Fig. 12

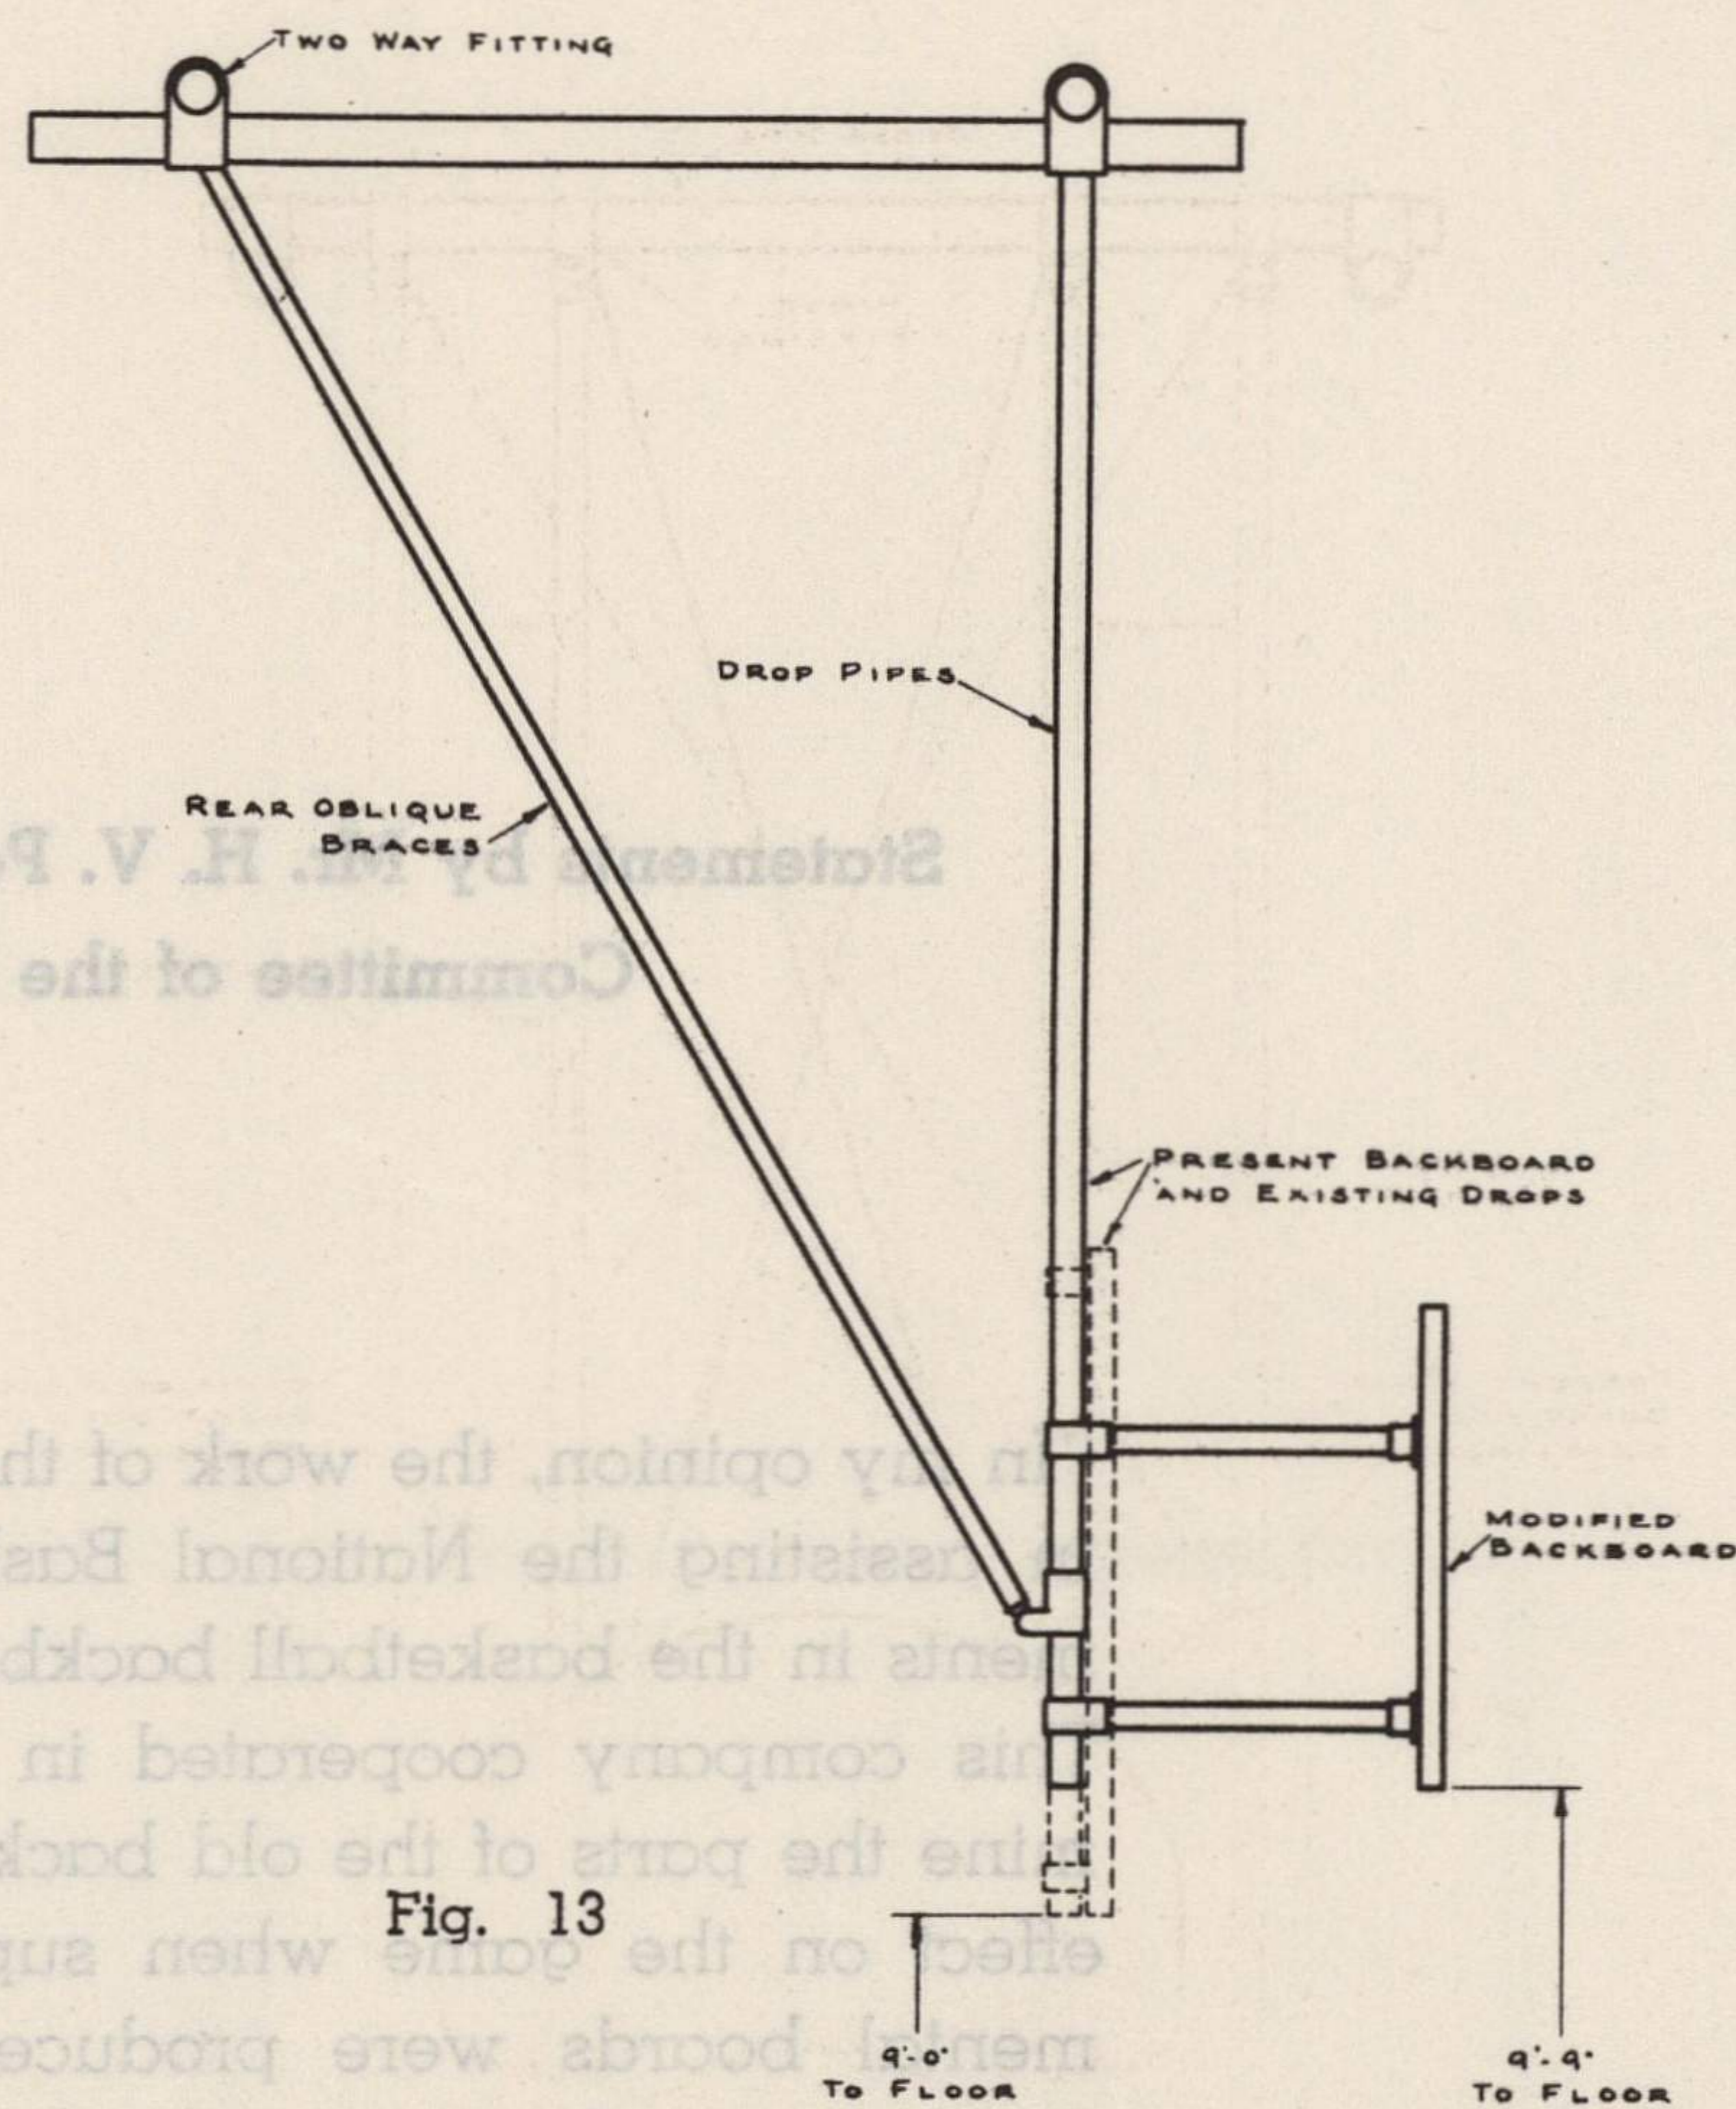
More simple and economical means of adapting the modified backboard to existing suspended swing-up structures is available (1) if it possible to shift the suspended parts 2 feet to the rear as shown in Fig. 12 or (2) if the floor lines can be placed 2 feet further inside the end lines of the court. In both cases the extension assembly per Fig. 12 and 13 is used. Incidentally this procedure will place backboards 4 feet inside the end lines as required by the rules.

Of the 2 suggestions offered on this page that illustrated in Fig. 12 involves the least expense and change in the present layout. Referring to Fig 12 it will be noted that the location of the backboard remains the same and it is only necessary that the suspended structure be set back 2 feet and the end line of the court be changed accordingly.
